Product Change Notice (PCN)

PCN Number: PCN-0381131R-01

- CLS0501M
- CLS0501M-L152

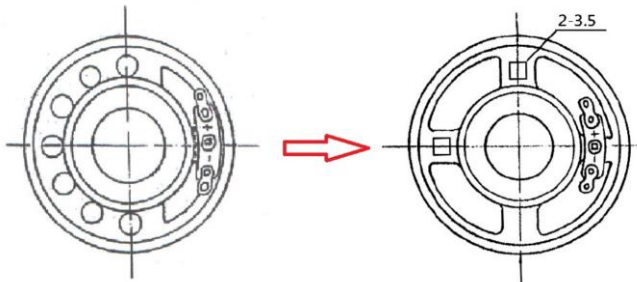
- SPL increased from 80dB to 84dB
- Frame shape has changed (Image Below)
